Access Compliance Report

Public Rights-of-Way

(Curb Ramps)

Intersection ID: 43667	Main Street: ASHETON_CREEK_DR	Cross Street: AVEN_CREEK_CT	Location: S
ADA ID: A95A017FAF8C	Ramp Type: Perp	Initial Pass/Fail: Pass	Overall Compliance: No
Severity Score: 10.25			
Codes/Mitigation Info/Possible Solution		Field Measurements/Component Compliance

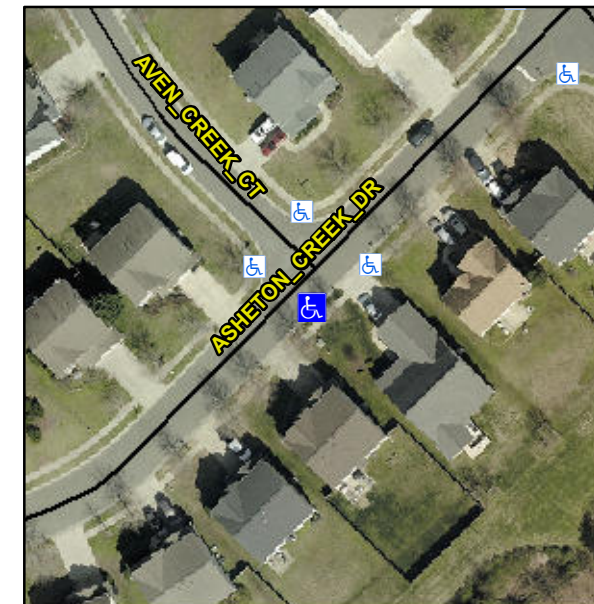
Not Found, R304.5.3, R304.2.2-Perp, R304.3.2-Para, R305

Compliance	Description	Data	Compliance	Description	Data
N/A	Ramp Length (in)	48.0	Yes	Ramp Slope (%)	6.5
Yes	Ramp Width (in)	49.0	No	Ramp XSlope (%)	3.8
N/A	Flare Type LT	Sloped	N/A	Flare Type RT	N/A
N/A	Flare Slope LT (%)	2.8	N/A	Flare Slope RT (%)	0.4
N/A	Flare Traversable LT?	No	N/A	Flare Traversable RT?	No
Yes	Landing Length (in)	48.0	No	DWS Provided?	No
Yes	Landing Width (in)	49.0	N/A	DWS Contrast?	No
No	Landing Slope (%)	3.5	N/A	DWS Length (in)	N/A
No	Landing X Slope (%)	3.0	N/A	DWS Full Width?	No
N/A	Landing Curb? (Y/N)	No	N/A	DWS Offset (in)	N/A
N/A	Shared Landing?	No			
Yes	Gutter Ponding?	No	Yes	Gutter Slope (%)	0.7
Yes	Gutter Lip Ht (in)	0.0	Yes	Gutter X Slope (%)	1.6
N/A	Painted X Walk1?	No	N/A	Painted X Walk2?	N/A
	X Walk 1 Direction	To NW		X Walk 2 Direction	N/A
N/A	X Walk 1 Width (in)	N/A	N/A	X Walk 2 Width (in)	N/A
	X Walk 1 Slope (%)	3.7		X Walk 2 Slope (%)	N/A
	X Walk 1 X Slope (%)	2.7		X Walk 2 X Slope (%)	N/A

N/A	Ramp inside XWalk1?	N/A	N/A	Ramp inside XWalk2?	N/A
	Road Slope (%)	N/A	N/A	Clear Space?	Yes
	Road X Slope (%)	N/A	N/A	Clear Space to XWalk (in)	N/A
Yes	Any Obstructions?	No	Yes	Storm Grate/Utility Hazard?	No
	Obstruction Type			Storm Grate/Utility Type	
		N/A			N/A
			Yes	Surface Condition? (G/P)	Good

Possible Solutions:

Remove & Replace Entire Ramp.
